Re: Further Application Information relating to Certification of Historic Unlicensed Waste Disposal and Recovery Activity Application in respect of Barnageeragh Landfill

Subject: Barnageeragh Landfill - Regulation 7 Notice H0167-01

RE: H0167-01 - Barnageeragh Landfill – Notice in accordance with Regulation 7(4) of the Waste Management (Certification of Historic Unlicenced Waste Disposal and Recovery Activity) Regulations, 2008

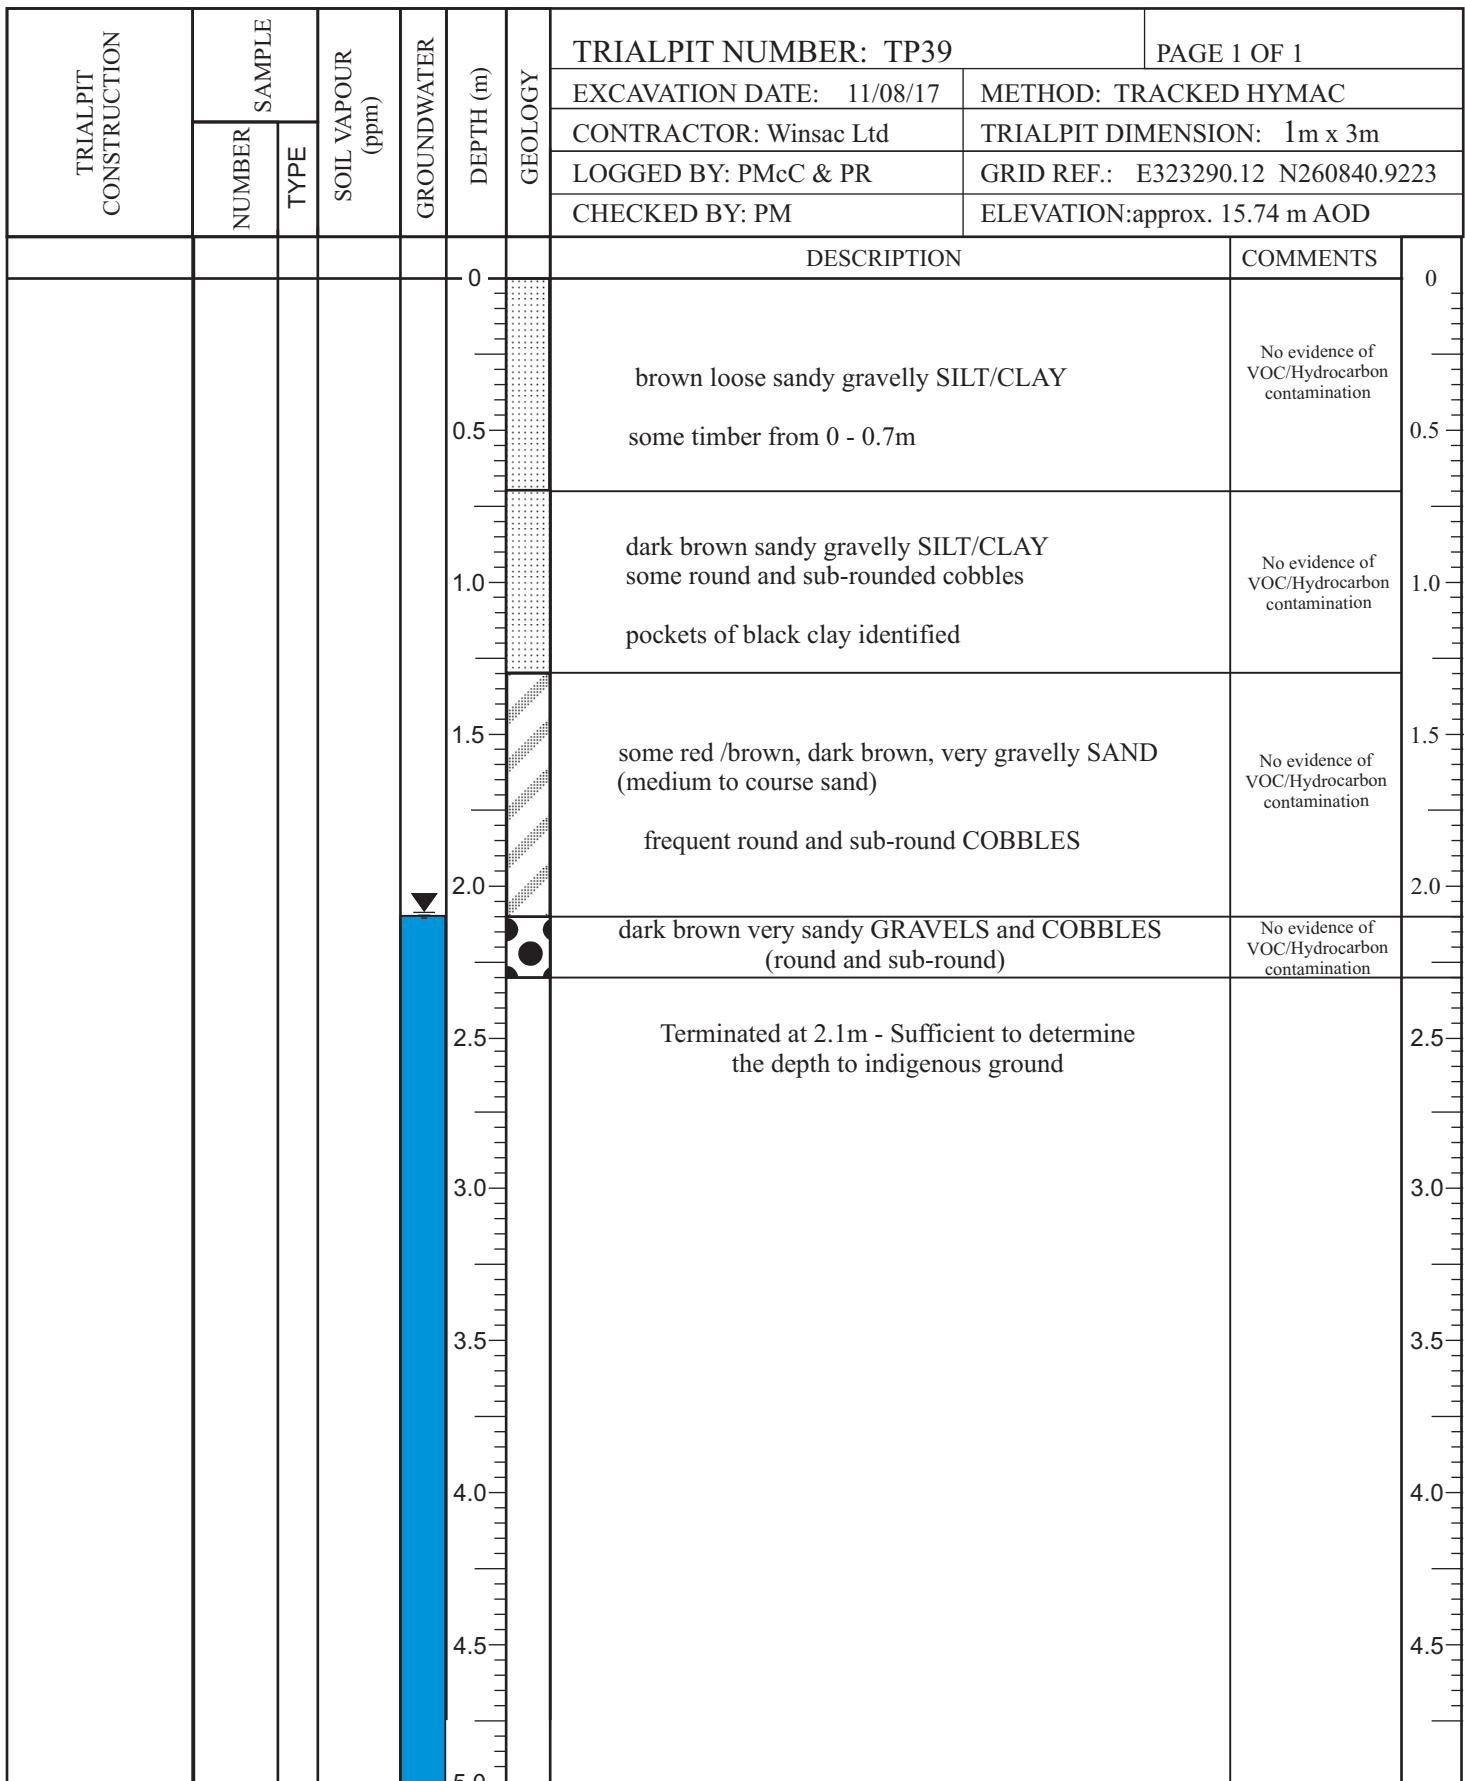
- (c) Area 2 is predominantly disturbed ground from on-site activities and not a body of waste material. The C&D waste encountered at both TP39 and TP43 was superficial only as summarised in the logs attached to this correspondence but also available in Appendix 6 of the Winsac DQRA. At TP39 some wood fragments were encountered in the top 0.7m. In TP43 some concrete and timber was

encountered in the top 0.5m. This material was as a result of construction activities on the site which was active at the time the trial pits were undertaken. It should be noted that this area of the site was used to store construction materials as is illustrated in Figure 7 of the Winsac DQRA. The area has been subsequently cleared of construction materials and landscaped with clean soil won from on-site activities. Therefore this area is considered to pose no risk of environmental pollution.

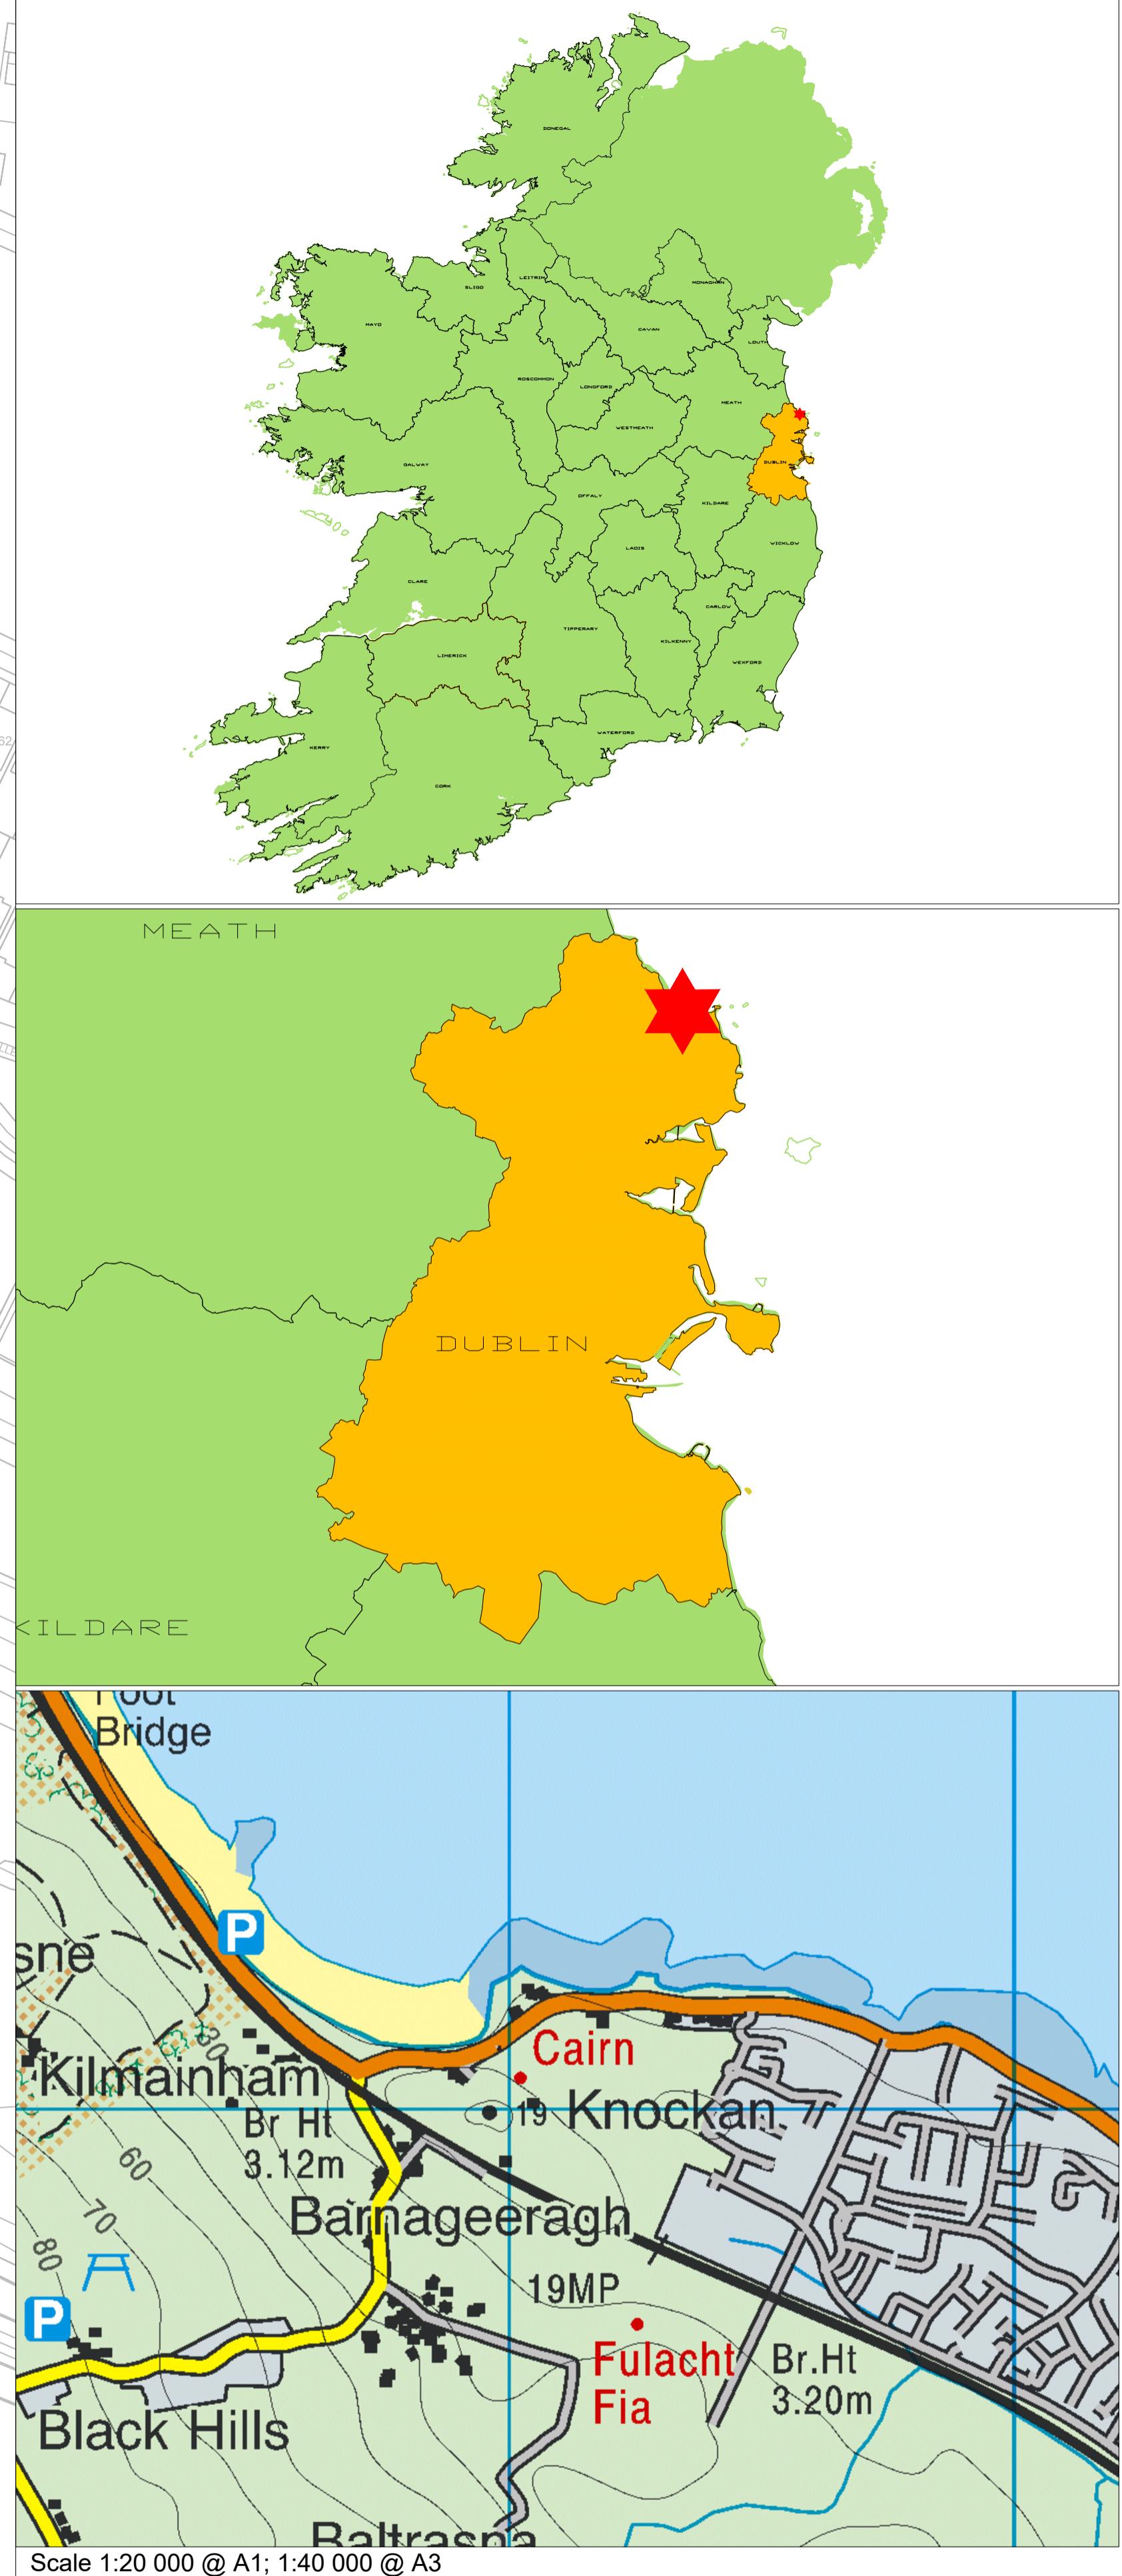
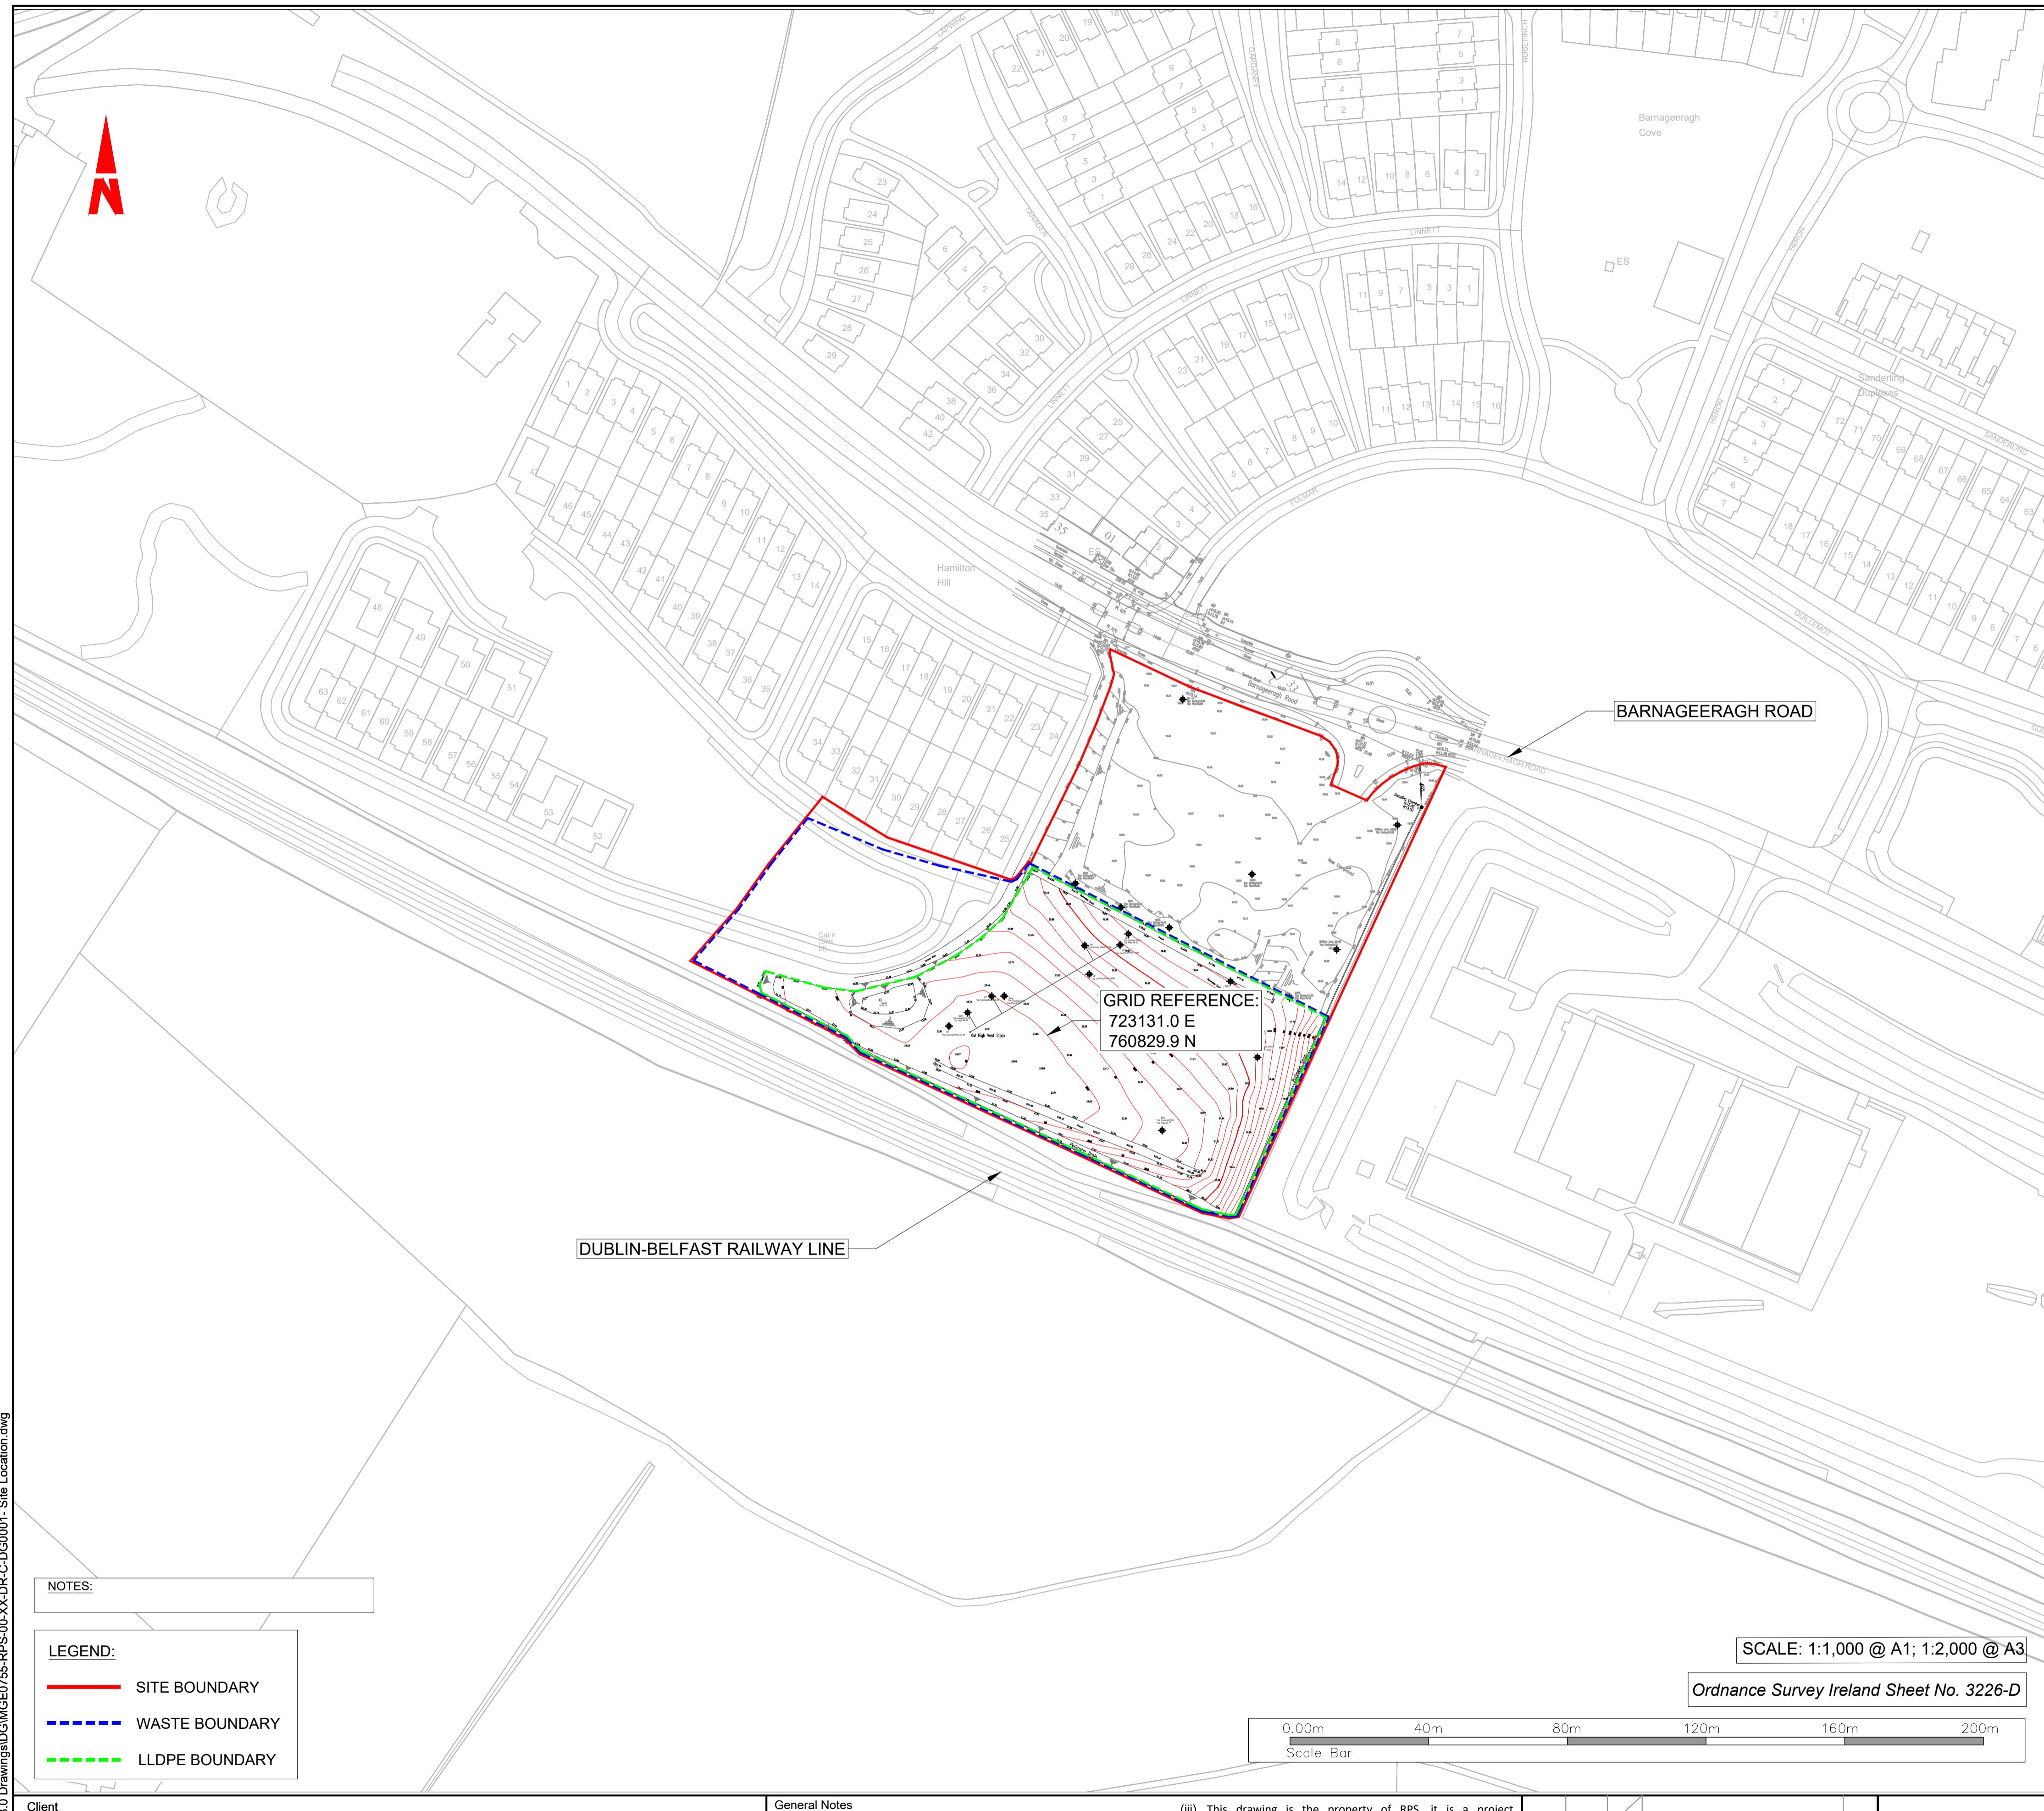
The attached updated drawing MGE0755-RPS-00-XX-DR-C-DG0001-01 is the correct drawing alongside drawing and MGE0755-RPS-00-XX-DR-C-DG0001-02. These drawings have been updated to incorporate a site survey completed by the developer in October 2020. The drawings show the site boundary, interpreted waste boundary and the line of the LLDPE capping. Section 1.2 of the non-technical summary has been updated to reflect this.

- (d) The site boundary on the drawings have been updated to include TP43.

The boundary of the site, the extent of the waste body and the proposed area of LLDPE landfill capping are shown on drawings MGE0755-RPS-00-XX-DR-C-DG0001-01 and MGE0755-RPS-00-XX-DR-C-DG0001-02.
